Rezoning Application: PD 22-0692
Zoning Hearing Master Date: September 19, 2022
BOCC Land Use Meeting Date: November 3, 2022

AGENCY REVIEW COMMENT SHEET

Application number:	RZ-PD 22-0692
Hearing date:	September 19, 2022
Applicant:	Arrow Capital, LLC
Request:	Rezone to Planned Development
Location:	East U.S. Highway 92, Tampa at the southwest corner of East U.S. Highway 92 and the intersection of I-4 and I-75
Parcel size:	27.8 acres +/-
Existing zoning:	CG and AR
Future land use designation:	UMU-20
Service area:	Urban Services Area
Community planning area:	East Lake-Orient Park Community Plan

2.4 Proposed Site Plan (partial provided below for size and orientation purposes. See Section 8.0 for full site plan)

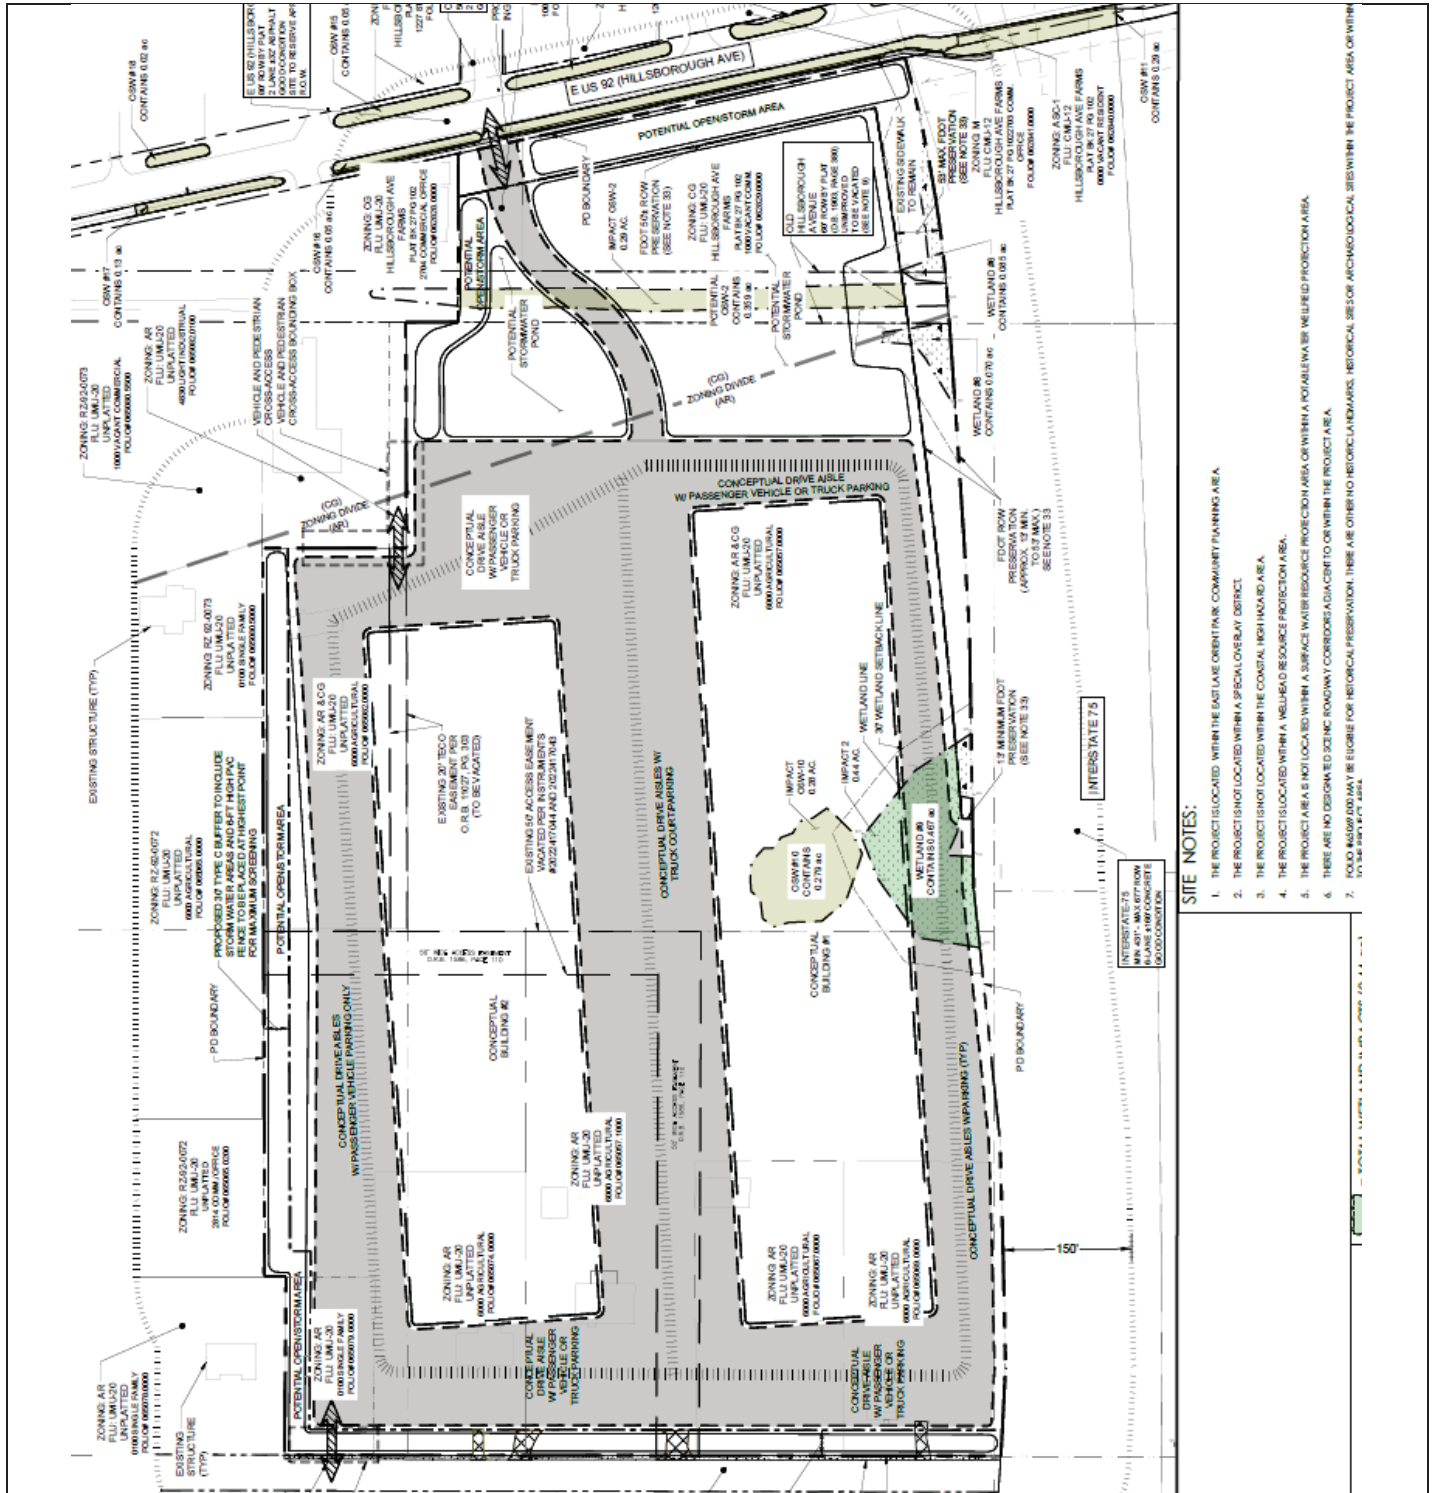
9. In accordance with the Hillsborough County Corridor Preservation Plan, the developer shall preserve +/-50 feet of right-of-way along its Hillsborough Ave.

10. In accordance with the Hillsborough County Corridor Preservation Plan, the developer shall preserve between +/-13 and +/-53 feet of right-of-way along a portion of its boundary along Interstate 75 as shown in the PD site plan.

11. The project shall provide vehicular and pedestrian cross access to folio# 65082.0100 within the bounding box shown on the PD site plan.
12. Notwithstanding anything shown on the site plan, ADA/sidewalk connections shall be provided from all site arrival points to all building entrances and parking areas.

17. Prior to the issuance of any building or land alteration permits or other development, the approved wetland / other surface water (OSW) line must be incorporated into the site plan. The wetland/ OSW line must appear on all site plans, labeled as "EPC Wetland Line", and the wetland must be labeled as "Wetland Conservation Area" pursuant to the Hillsborough County Land Development Code (LDC).

20. This site contains trees that qualify as Grand Oaks as defined by the Land Development Code (LDC). All trees confirmed as a Grand Oak must be accurately located and labeled as such on the submitted preliminary plan/plat through the Site Development/Subdivision Review process. Design efforts are to be displayed on the submitted preliminary plan to avoid adverse impacts to these trees.

21. Wetlands or other surface waters are considered Environmentally Sensitive Areas and are subject to Conservation Area and Preservation Area setbacks. A minimum setback of 30 feet must be maintained around these areas which shall be designated on all future plan submittals. Proposed land alterations are restricted within the wetland setback areas.

Pedestrian Sight Triangle Example:

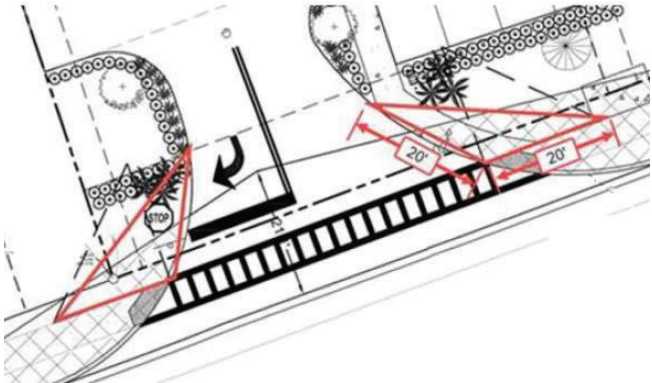
Driveways leading onto state roads need to have min. 20' x 20' clear 'pedestrian sight triangles' on each side of the driveway, at the edge of the sidewalk. It should be measured as 20' up the sidewalk and 20' up the driveway from the point at which the sidewalk meets the driveway. Nothing above 2' in height from the pavement elevation (except for the stop signpost) should be placed in these triangles. Also, no parking spaces should be in these triangles, not even partially. Please draw in and label these 'pedestrian sight triangles' on the plans. Here is an example of what these triangles look like and how they are positioned (see red triangles in the attached example)
